**Town of Rotterdam
Planning Commission
December 6, 2022**

DPW Comments
December 6, 2022

To: Peter Comenzo, Senior Planner – Town of Rotterdam
From: Daniel Farnan, PE, CPESC, CPSWQ
Date: November 14, 2022
Subject: ELP Rotterdam Solar – **Initial Application Completeness Review**
Project No.: CED: 21002349G - 003

Figure 1 Section of ELP Rotterdam Solar Boundary Survey

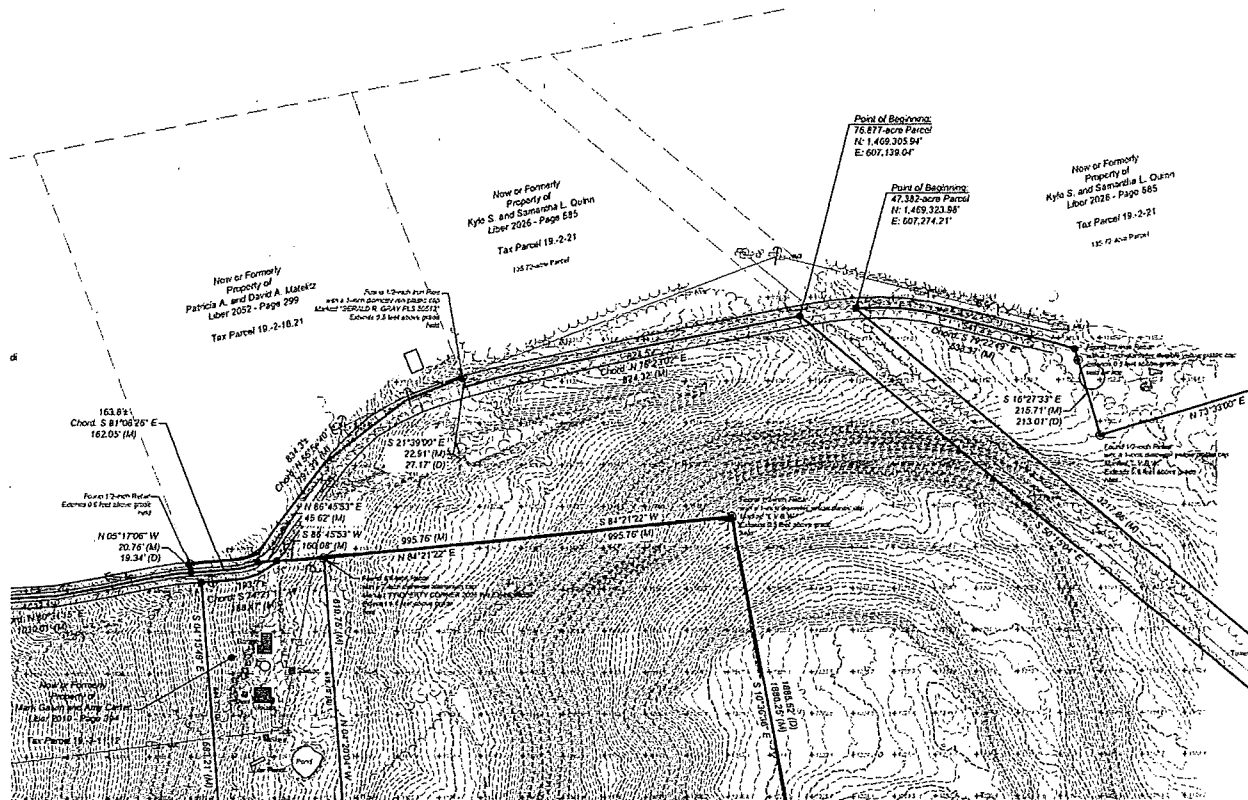
- a. Please revise the gray solid hatch for areas to be cleared so the underlying aerial image is viewable.
- b. While visiting the site in September, our office noticed "Private Property" signs near the end of Sandborn Road before the project's proposed entrance location. Please provide deeded evidence or a stamped survey showing an official "Right of Way" on Sanborn Road. Otherwise, please provide necessary proposed easements that would allow access rights to the site for both the solar operator, the utility, and for the Town to access for emergency services.

A survey of the property has been conducted including a review of all relevant deed information of nearby properties. The snip of the survey below illustrates that the property line extends to the centerline of the private road.

No easements are required to access either Sandborn Road or the private road east of Sandborn Road. Full deed information will be provided electronically, however, in an effort to limit the amount of printing we have not included the deed information as an attachment to this letter.
